UNITED STATES ENVIRONMENTAL PROTECTION AGENCY
REGION IX
75 Hawthorne Street
San Francisco, CA

EPA Review of Draft *Radiological Data Evaluation Findings Report for Parcels B and G Soil, Former Hunters Point Naval Shipyard, San Francisco, California, September 2017.*

EPA Comments dated December 2017

PARCEL B – TU 186

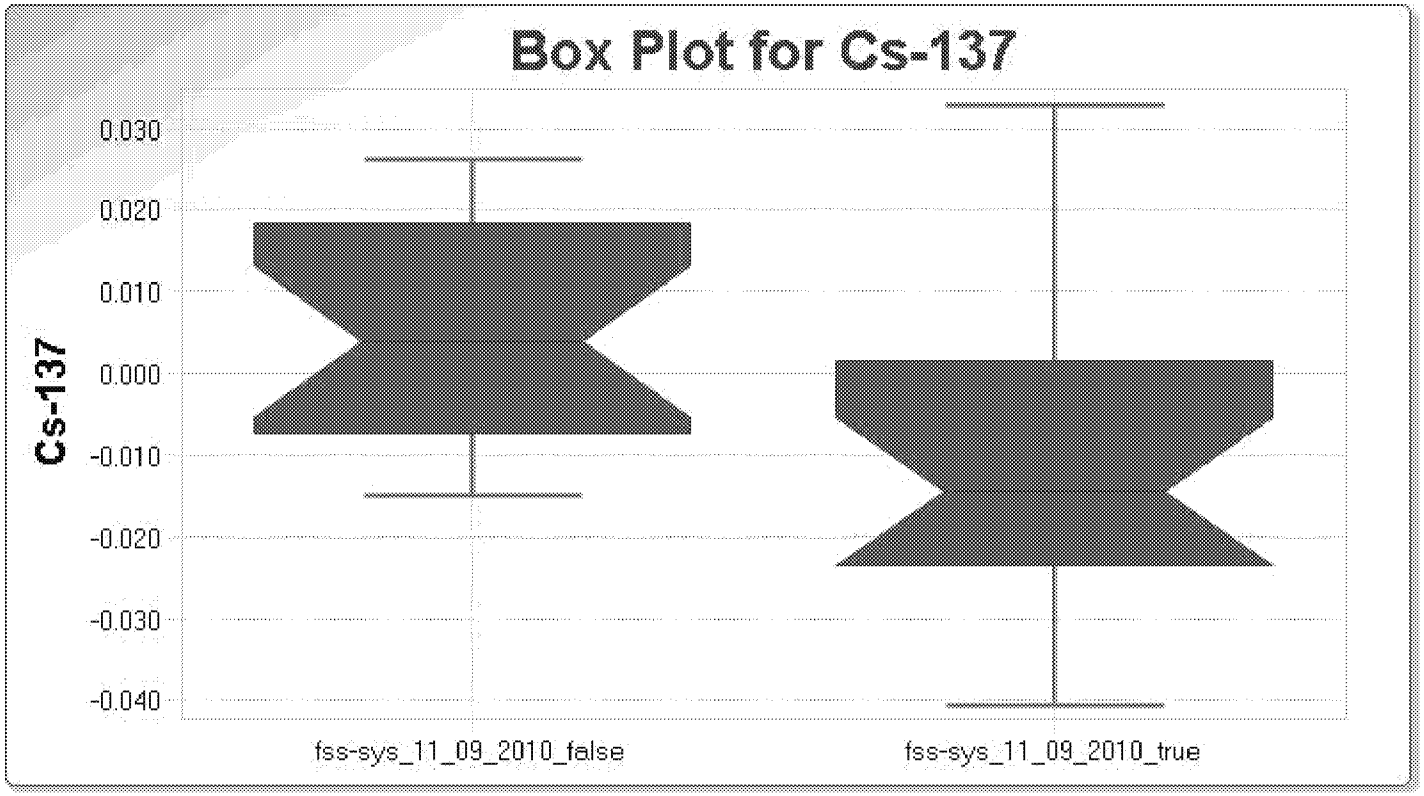
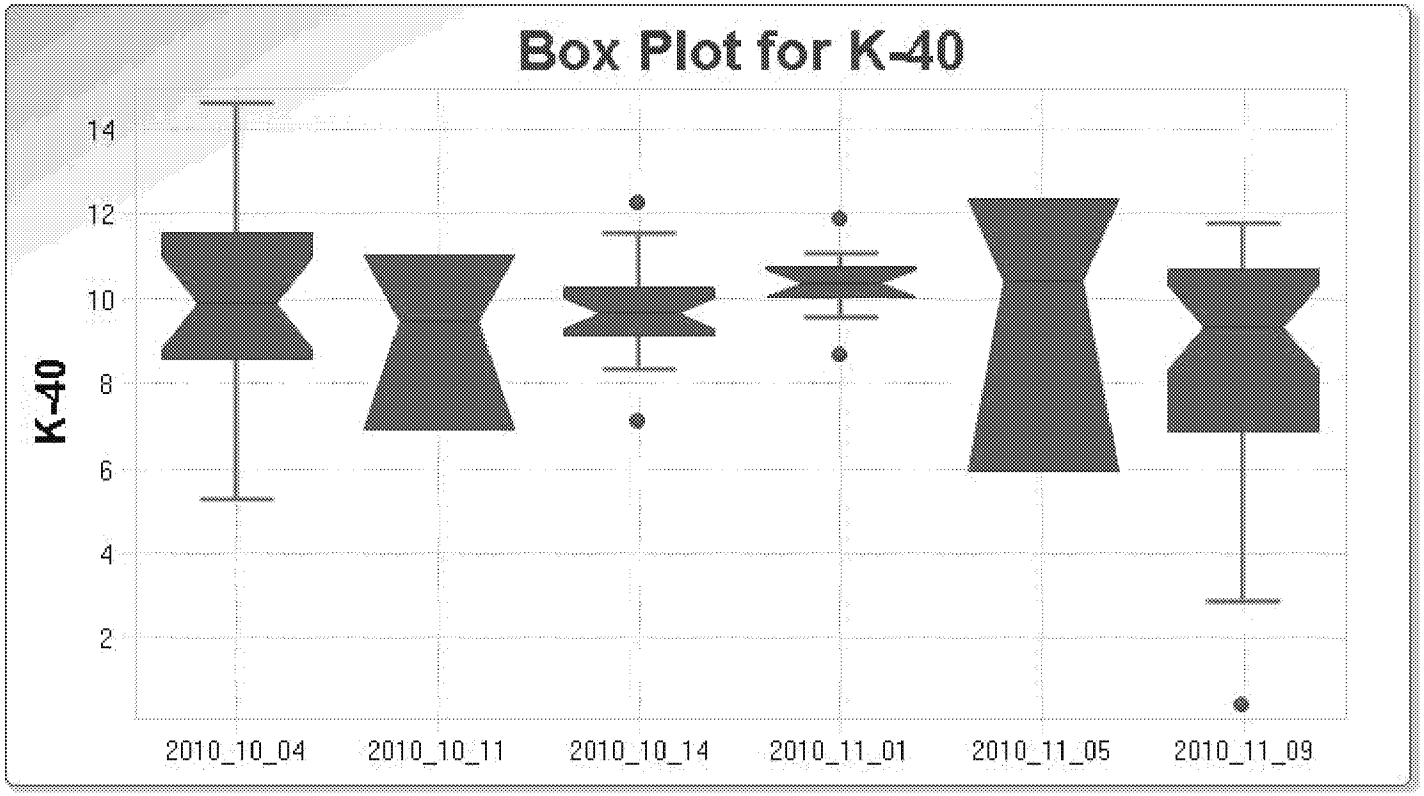
Note: Wide spread for 11/09/2010 – examining data shows 19 samples for on-site analysis and 19 samples for off-site analysis. Prompted me to explore the spread by breaking out the two types of analyses. Figure below shows the on-site analysis resulted in lower results explaining the presence of the spread in the plot above. The off-site analysis shows similar variability to the other 5 events.
